Access Compliance Report

(Curb Ramps)

Intersection ID: 14762	Main Street: E_TREMONT_AV	Cross Street: SPRINGDALE_AV	Location: W
ADA ID: 805235A0FA09	Ramp Type: Directional1	Initial Pass/Fail: Fail	Overall Compliance: No
Severity Score: 37.5			
Codes/Mitigation Info/Possible Solution		Field Measurements/Component Compliance

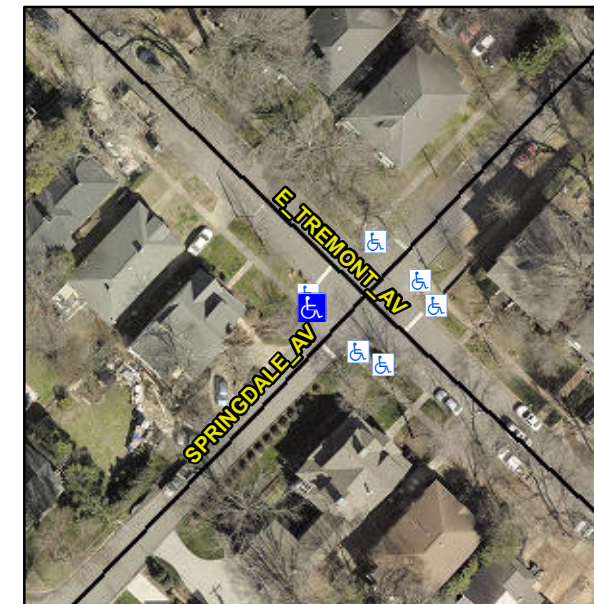
WATER VALVE LIP 1.0"

R304.2.2, R304.5.3

Remove & Replace Entire Ramp.
